TO: **COUNCIL ASSESSMENT PANEL**
 DATE: **28 OCTOBER 2020**
 SUBJECT: **COUNCIL ASSESSMENT REPORT**
 AUTHOR: **DEAN SPASIC**
DEVELOPMENT OFFICER - PLANNING

DA NO.	:	110/00372/20
APPLICANT	:	GEORGE CHRISTOPOULOS
LOCATION	:	681 BRIGHTON ROAD, SEACLIFF
DEVELOPMENT PLAN	:	CONSOLIDATED 2 JUNE 2016
ZONE AND POLICY AREA	:	RESIDENTIAL ZONE, MEDIUM DENSITY POLICY AREA 5
NATURE OF DEVELOPMENT:		MERIT
PROPOSAL	:	FOUR, TWO STOREY GROUP DWELLINGS
EXISTING USE	:	RESIDENTIAL
CATEGORY	:	TWO
REPRESENTATIONS	:	ONE
RECOMMENDATION	:	DEVELOPMENT PLAN CONSENT SUBJECT TO CONDITIONS

Development No.	110/00372/20 – Amended Plan (dated 11 September 2020)
Applicant	George Christopoulos
Location	681 Brighton Road, Seacliff (CT 5836/570)
Proposal	Construct four two storey dwellings with shared access

DWG NO. BRI-681-19.dwg

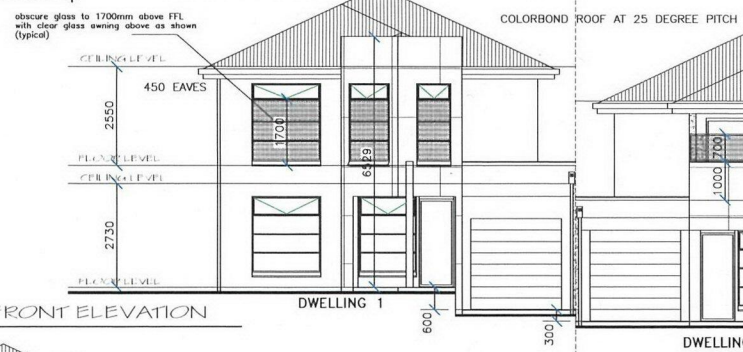
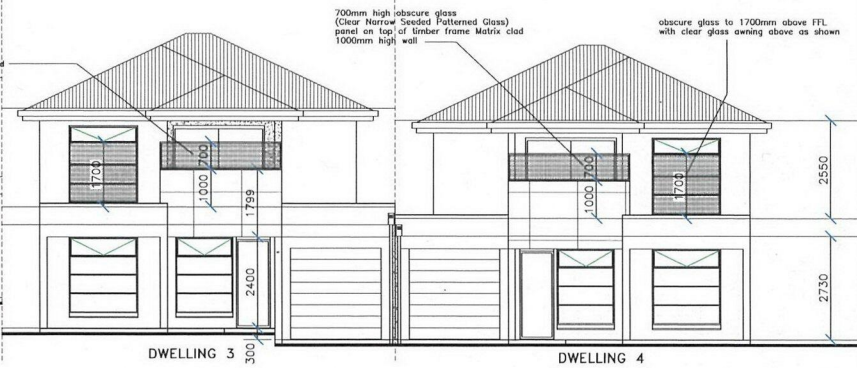
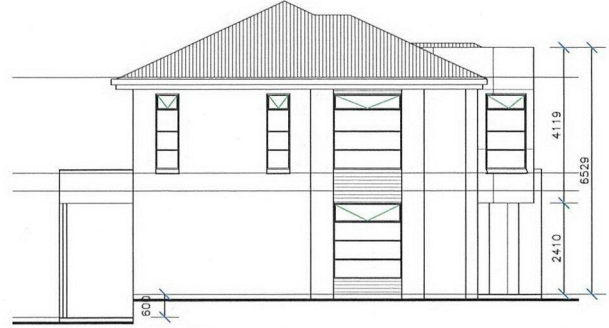
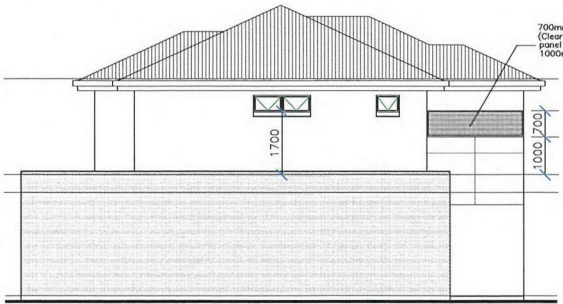
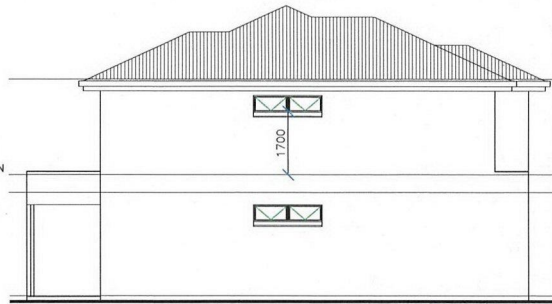
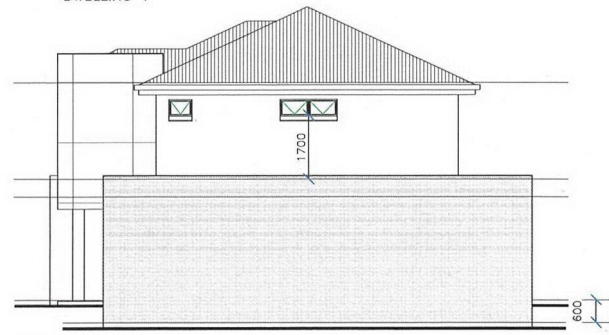
We are not comfortable with any balconies or windows (upper level, front elevation) looking over and into our property. By looking at the plans, it seems all 4 proposed dwellings currently do this.

Side elevation of elevation 1 may also look into our property depending on whether elevation shown is the east or west side???

By all balconies to be removed from the front elevation (or any side that will be in view of our ~~pro~~ backyard; and/or living room/kitchen. Additionally all windows in view of our backyard/in side our house to be removed, placed high enough so no-one can look out of them or installed with frosted glass.

We have attempted to negotiate a solution and part of the way with the glazing but not the permanent screens to the balconies. We offered 1.8 m ie 800mm louvred screen above the balcony wall. They are insisted they would only agree to a louvred screening above the balcony wall to a height of 2.0 m. We provided them a Line of sight diagram showing an 800mm high louvred above the wall was more than adequate

Kane and Tess are insisting of permanent screening to a height of 2.0m above the Balcony Floor level which in our opinion is excessive and unwarranted..

3. That all upstairs windows, except for the eastern elevation of 'Dwelling 1' shall have minimum window sill heights of 1.7 metres above finished floor level, or any glass below 1.7 metres shall be manufactured obscure glass and fixed shut or as otherwise approved by Council. Further details of this requirement shall be provided at Building Rules Assessment stage.

4. All upstairs balconies shall have fixed screens up to 1.7 metres in height above the balcony floor level so as to prevent views into adjacent residential properties.

700mm high obscure glass (Clear Narrow Seeded Patterned Glass) panel on top of timber frame Matrix clad 1000mm high wall

We have advised them that 2.0 m high screening is unacceptable and we will seek 1700mm high permanent screening (with a 700mm privacy screen on top of the balcony wall) in accordance with Council Wide Residential Development PDC 40.

Damien Griffin is presently amending the drawings to include 1700 mm reeded glazing and a 700mm privacy screen notation to the western and northern elevations and setting the garages for dwellings 2 and 4 to 600mm from the rear boundary and cantillating their verandahs to facilitate adequate revering manoeuvres.
